# ALERT SERVICE BULLETIN

SUBJECT: **REVISION "A" TO ALERT SERVICE BULLETIN 407-00-36: (170 AMP MAXIMUM CONTINUOUS ELECTRICAL LOAD LIMIT FOR OPERATIONS ABOVE 10,000' DENSITY ALTITUDE, INTRODUCTION OF)**

**NO.** 407-00-36

**SUBJECT:** 170 AMP MAXIMUM CONTINUOUS ELECTRICAL LOAD LIMIT FOR OPERATIONS ABOVE 10,000' DENSITY ALTITUDE, INTRODUCTION OF

Figure 1. Addition of Decal at 170 Ampere Position on Indicator

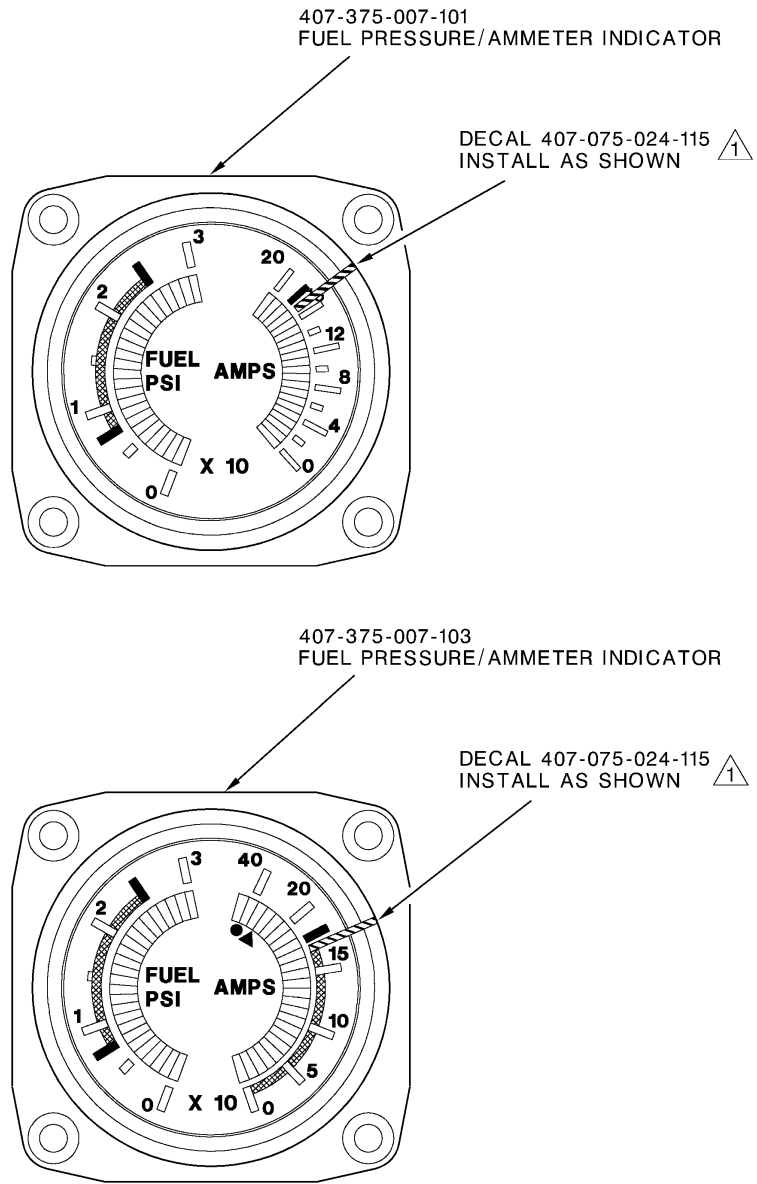
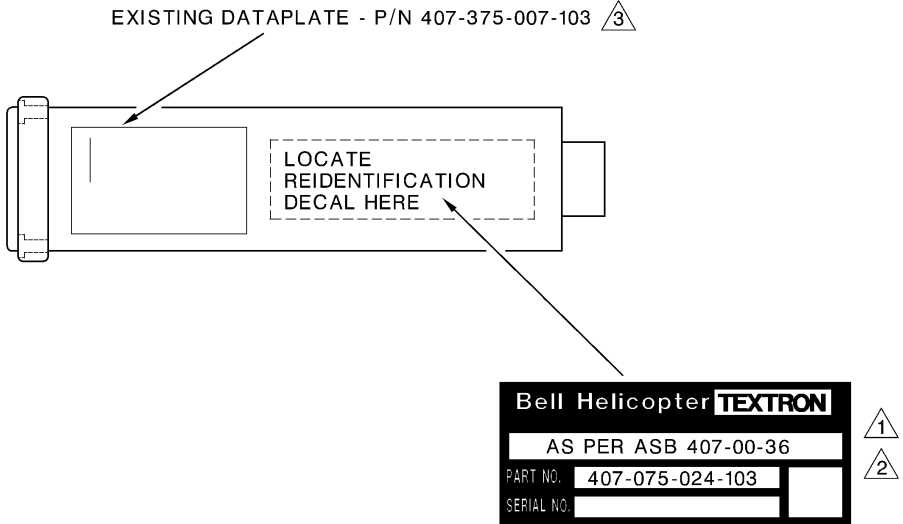
5. Being careful not to touch the cleaned glass cover and bezel of indicator with fingers, apply decal P/N 407-075-024-115 to P/N 407-375-007-101 or -103 indicator as shown in Figure 1. Apply decal on the glass cover and bezel of the indicator, over the 170 ampere position. Once decal is confirmed to be located in the proper position use finger pressure to ensure decal is securely adhered.
6. With reference to Figure 2, use a ball point pen to notate identification plate P/N 100-088-1 as shown. The notated 100-088-1 plate will be used to reidentify the indicator to P/N 407-075-024-101 or-103.

**NOTE**  
1 Install decal in appropriate position for indicator part number.

**Figure 2. Instrument Reidentification**

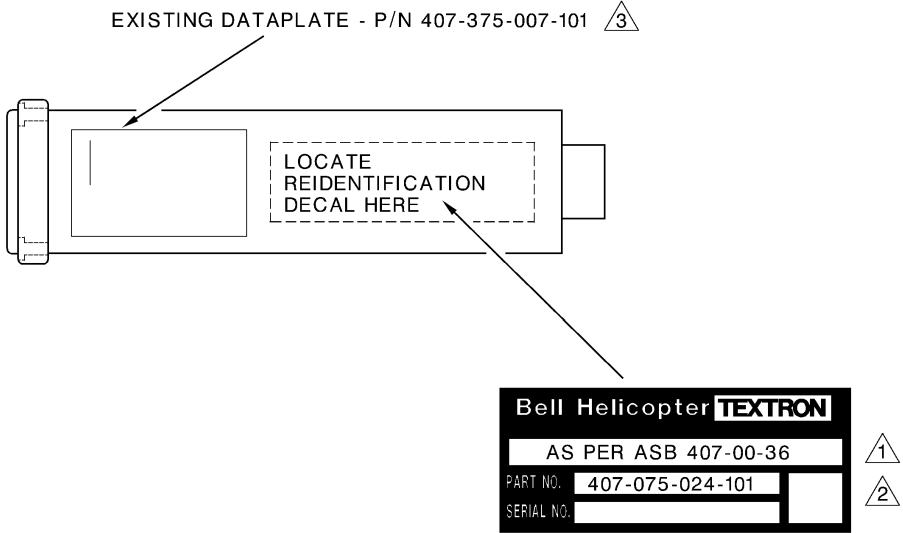
7. Peel off protective backing from notated identification plate and adhere to instrument as shown in figure 2.
8. Using a ballpoint pen, put a line through the P/N 407-375-007-101 or -103 displayed on the indicators original data plate.
9. Install modified Fuel Pressure / Ammeter indicator to instrument panel with 4 screws. Install electrical connector to indicator.
10. Use the hardware you removed to close the instrument panel.
11. Apply electrical power and confirm Fuel Pressure / Ammeter indicator completes power up self-test.
12. Insert the following revisions into the 407 Flight Manual:

- <sup>1</sup> Reidentification plate P/N 100-088-1 is provided blank
  - Prior to installation, notate plate as shown for applicable indicator with ball point pen.
  - Use sufficient pen pressure to indent notation on plate.
  - Include existing serial number of indicator in space provided.
- <sup>2</sup> After plate has been notated, peel off protective backing and install plate on instrument in location shown.
- <sup>3</sup> Use ball point pen to put single line through original part number of indicator in location shown.
